**COUNTY OF SAN MATEO
PLANNING AND BUILDING DEPARTMENT**

SUBJECT: EXECUTIVE SUMMARY: Consideration of a Design Review Permit, a Coastal Development Permit, and a Certificate of Compliance (Type B) to legalize a 6,079 sq. ft. parcel and to allow construction of a new 2,909 sq. ft. single-family residence, including a 728 sq. ft. two-car garage and shop area, on the subject property, and an approximate 33-ft. public roadway extension of Sevilla Avenue (30-ft. wide) to serve the project. The project is located on Sevilla Avenue between Madrona Avenue and Sonora Avenue in the unincorporated El Granada area of San Mateo County. The project is appealable to the California Coastal Commission.

County File Number: PLN 2016-00153 (Menendez)

SUBJECT: Consideration of a Design Review Permit and a Coastal Development Permit, pursuant to Sections 6565.3 and 6328.4 of the County Zoning Regulations, as well as a Certificate of Compliance (Type B) to legalize a 6,079 sq. ft. parcel, pursuant to Section 7134.2 of the County Subdivision Regulations, to allow construction of a new 2,909 sq. ft. single-family residence, including a 728 sq. ft. two-car garage and shop area, on the subject property, a

2 RIGHT SIDE ELEVATION
Scale: 1/4" = 1'-0"

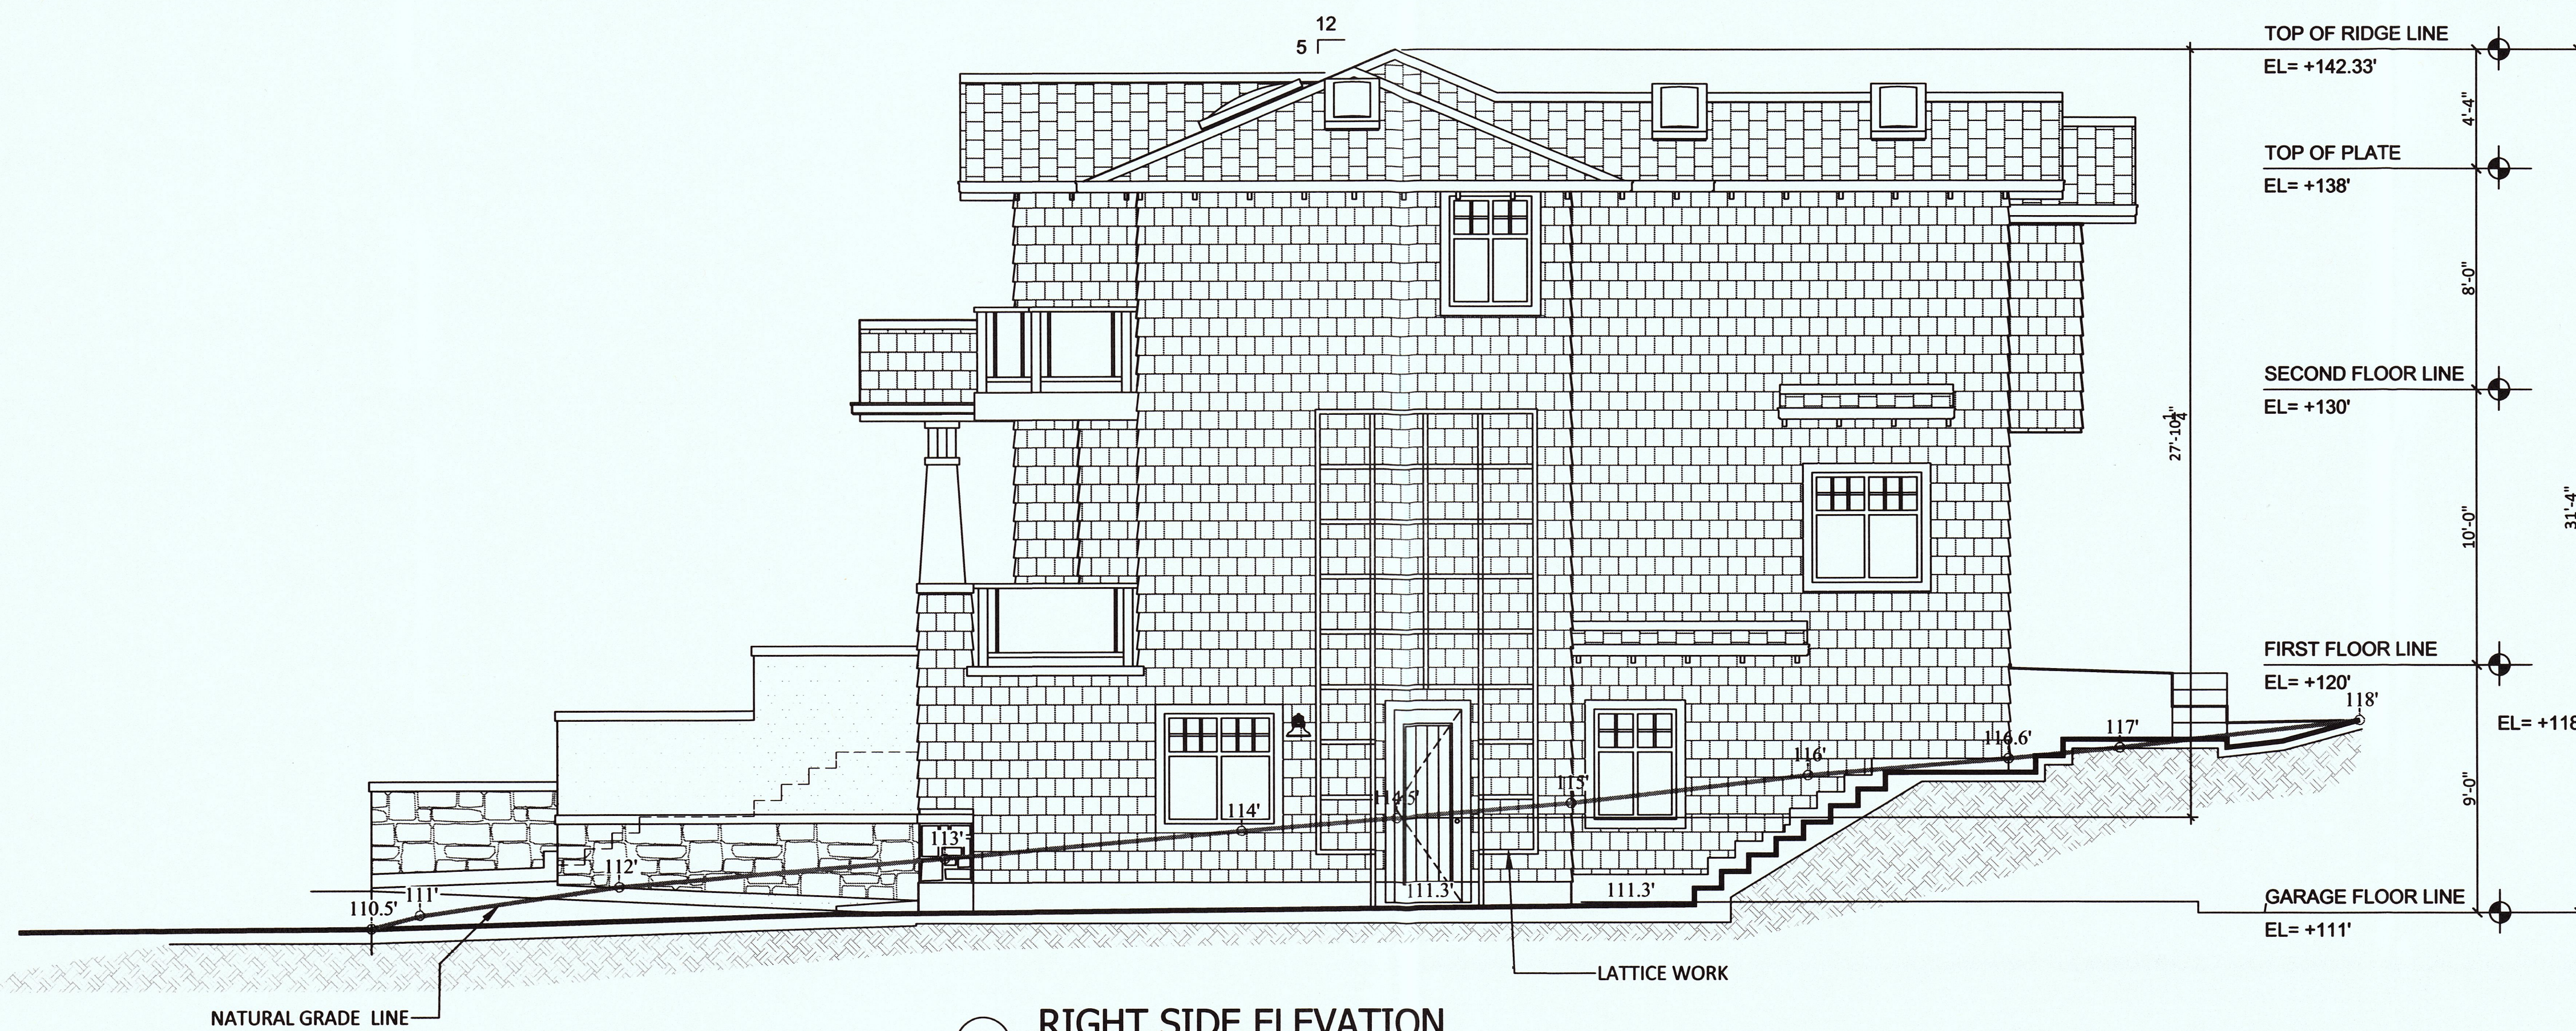
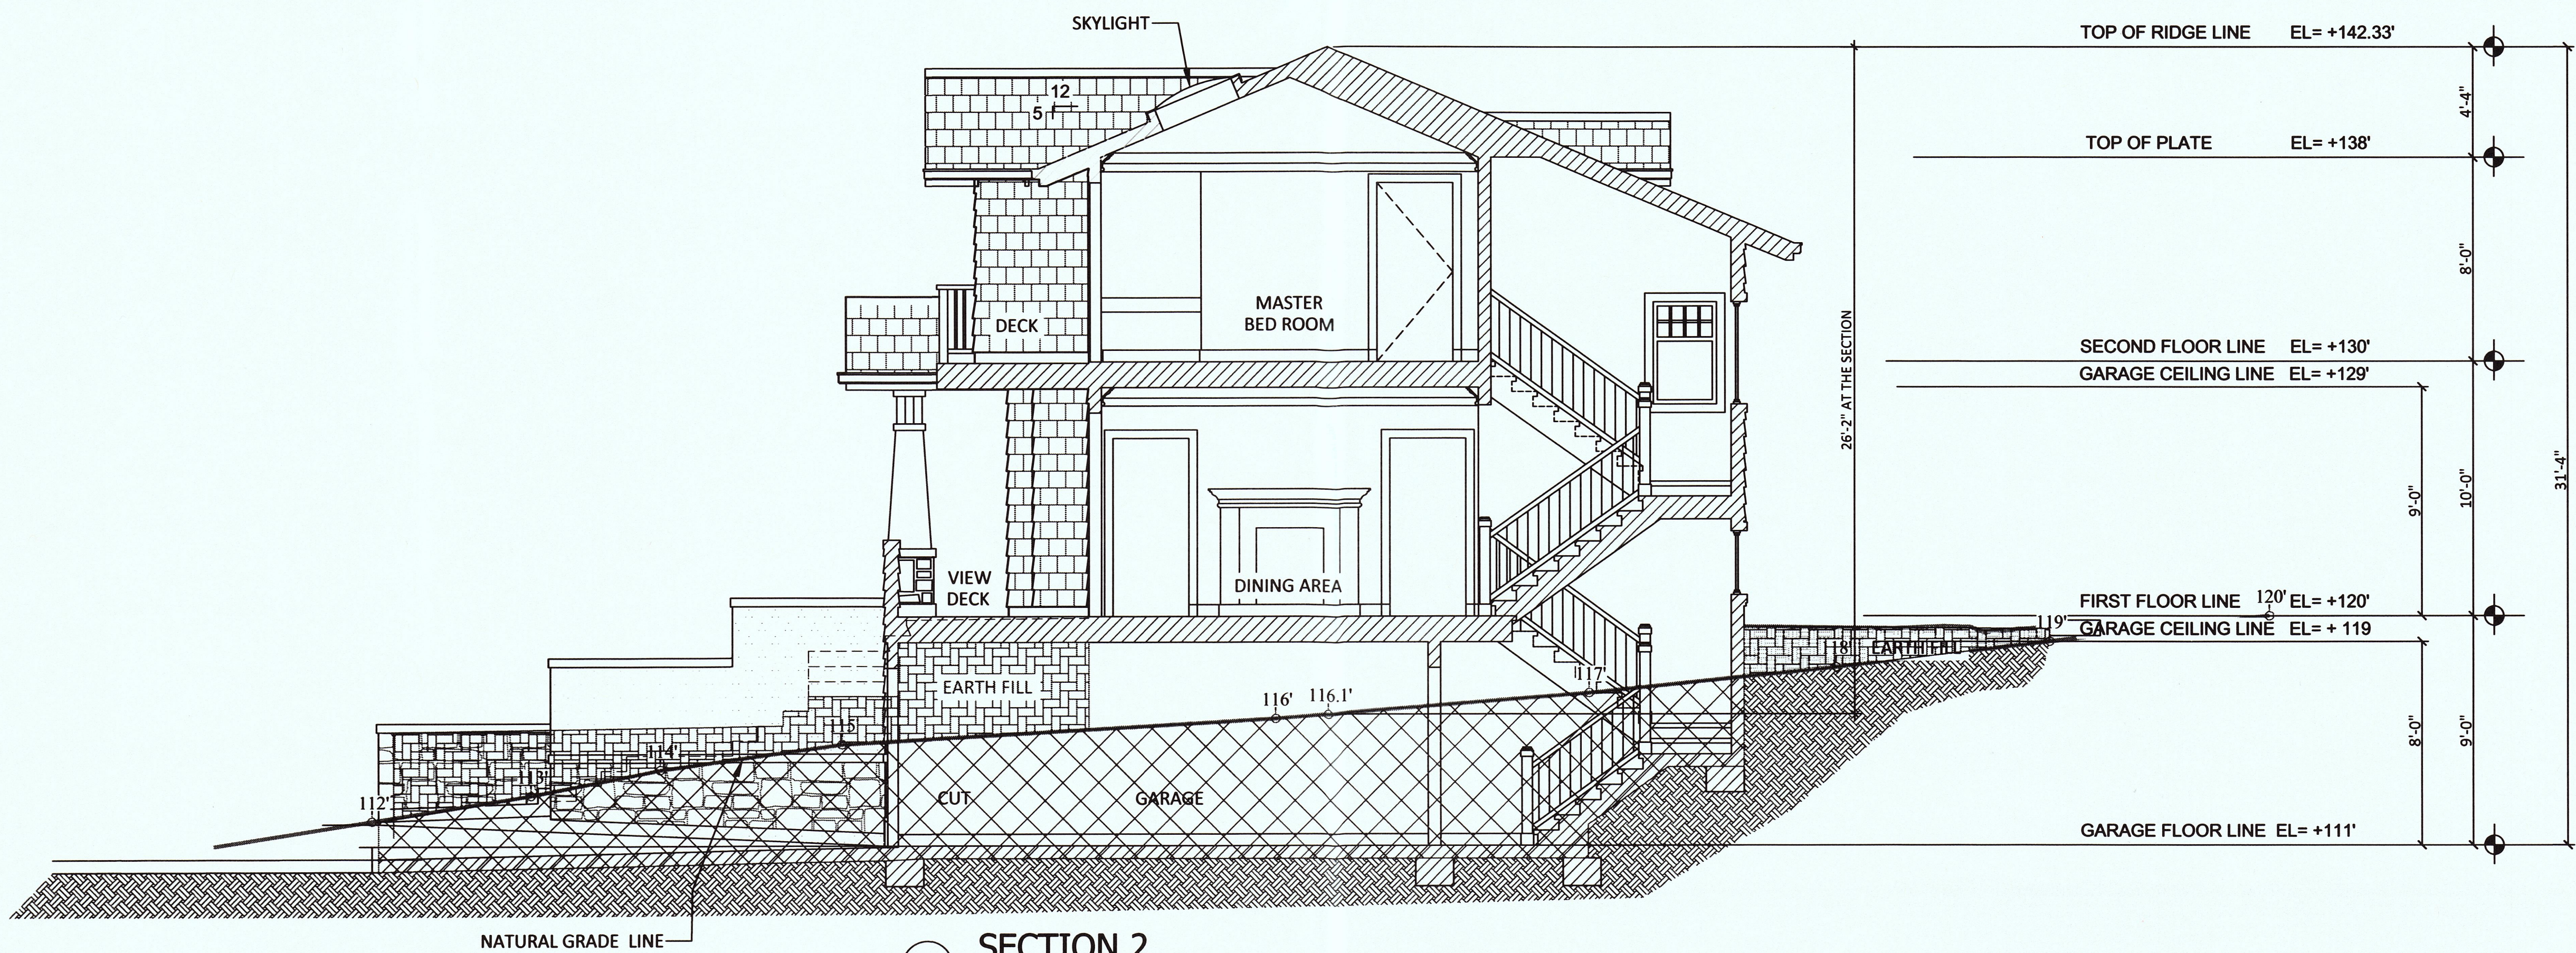
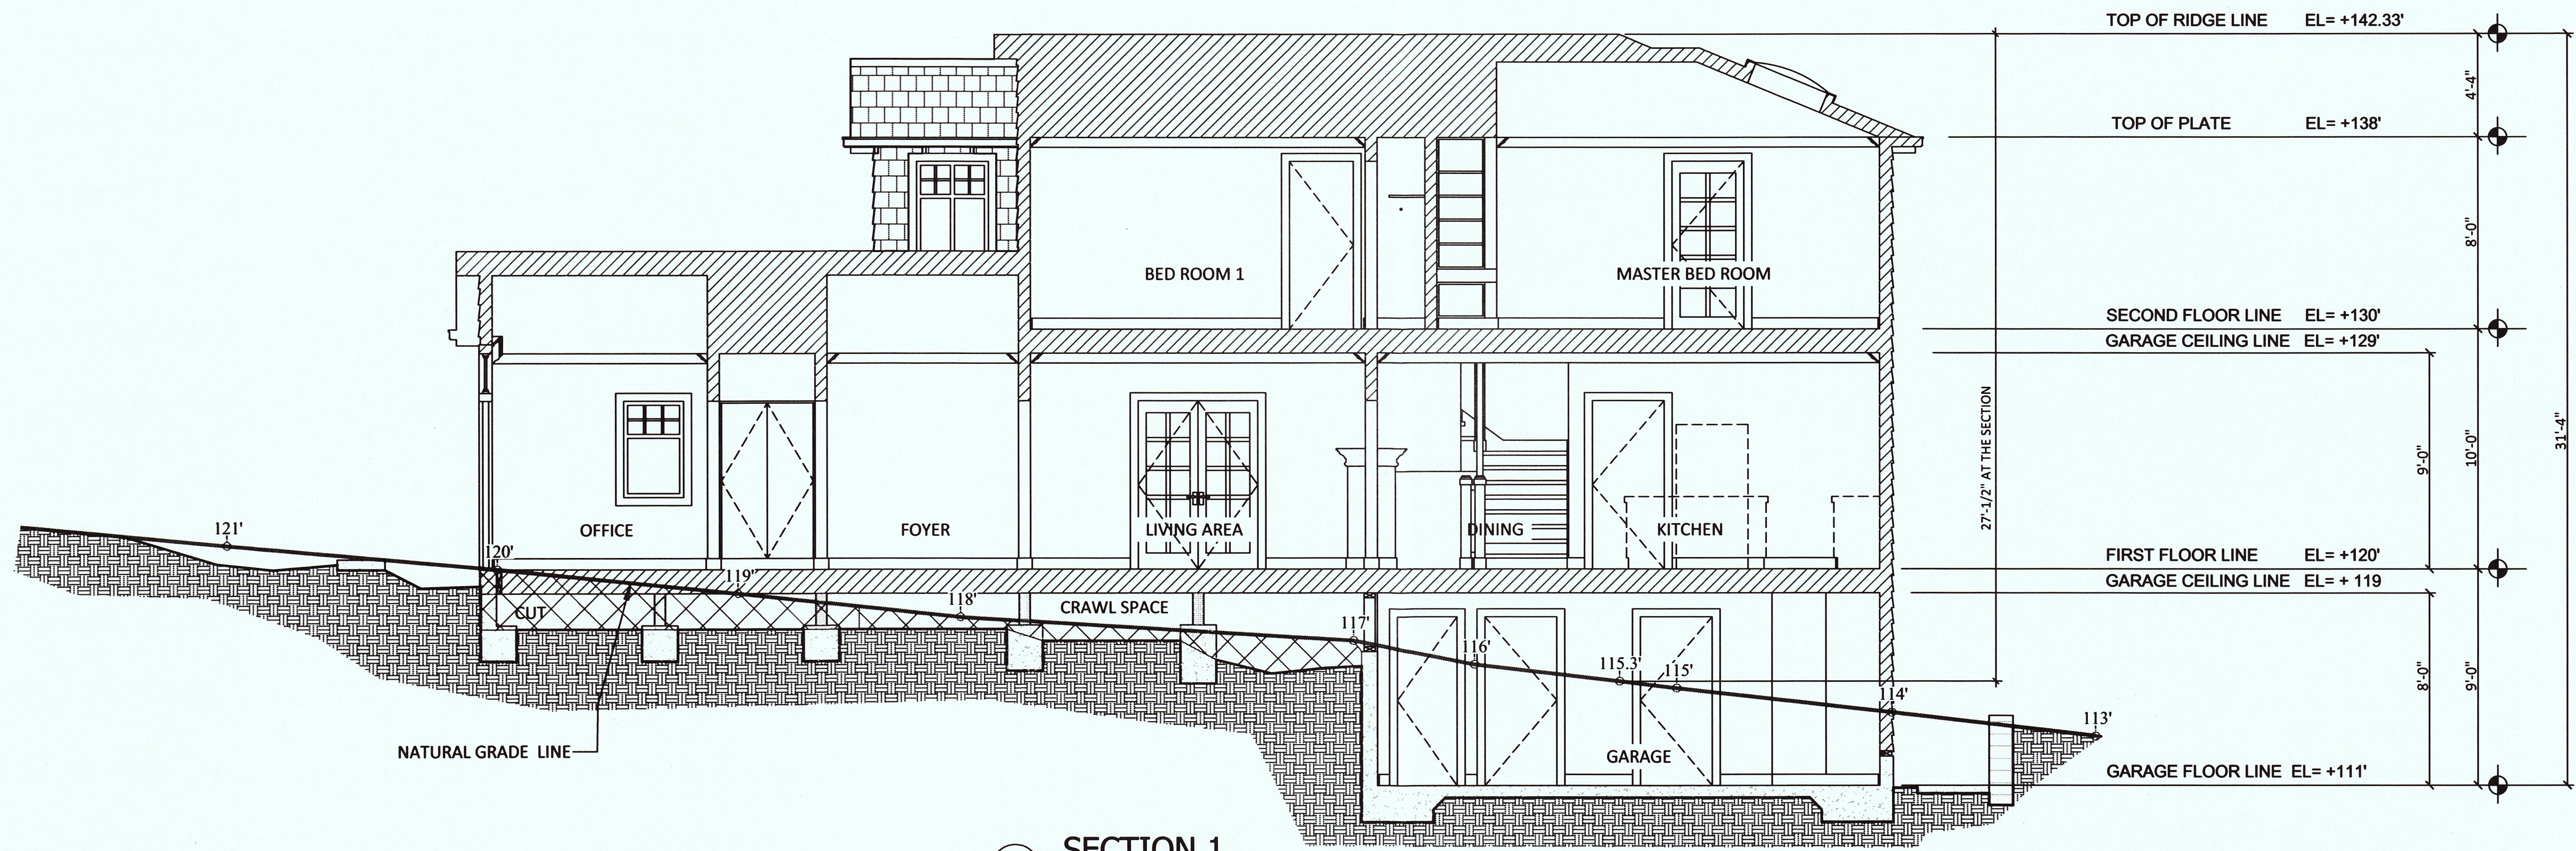
- a. Replace bark with wild grass seed in landscape areas.
- b. Use permeable pavers in lieu of stamped concrete, for all patios (at a minimum).
- c. Use a maximum of one exterior light per door except for the garage where two lights is acceptable per the proposed design.
- d. Add a belly band to right-side elevation at the same height as the second level deck.
